TRANSPORTATION BULLETIN

ADDENDUM NO. 1

Item No. 1A – New Airfield Lighting Vault

University of Illinois - Willard Airport
Savoy, Illinois
Champaign County
IL Project No.: CMI-4100
AIP Project No.: 3-17-0016-xx
Contract No.: UN051

SECTION THRU FOUNDATION

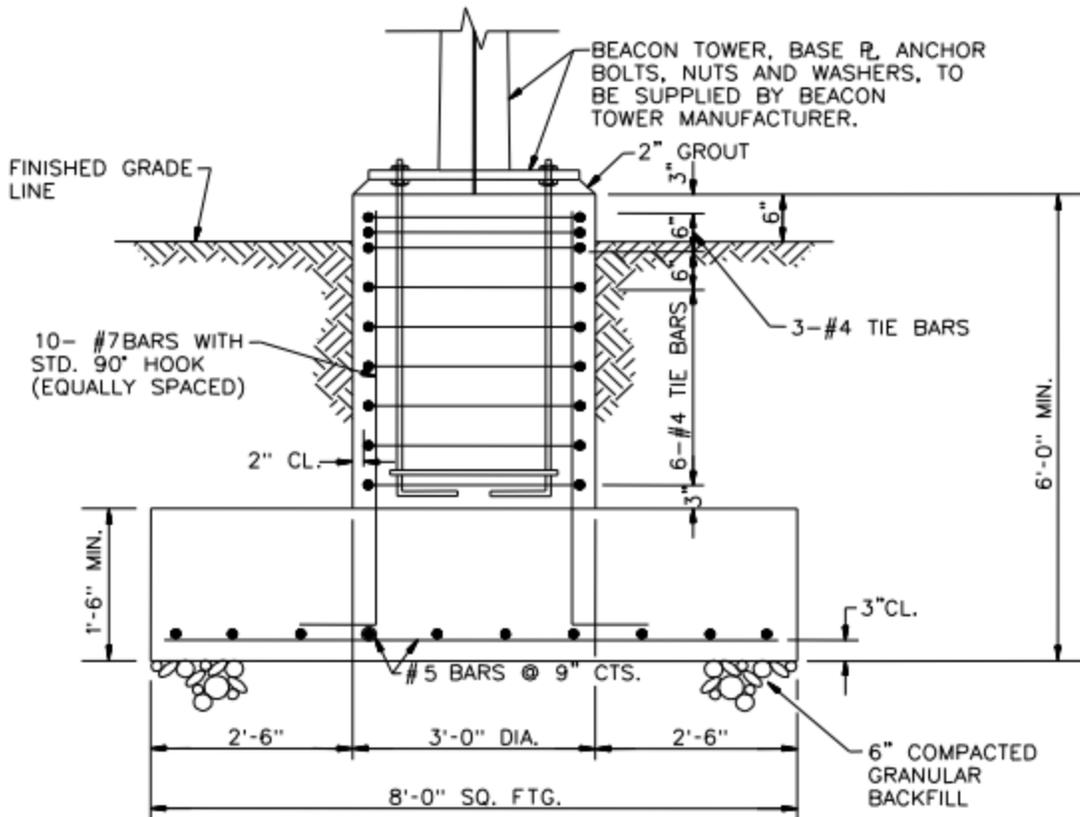
Replace Plan Sheet 27 with Revised Plan Sheet 27 of 60.

1. Replace all references to "8000-25TP" to read "8000-50TP". Pole shall be 50 foot tubular steel airport beacon tipdown pole, Hali-Brite, or equivalent.
2. Replace SECTION THRU FOUNDATION detail with the following:
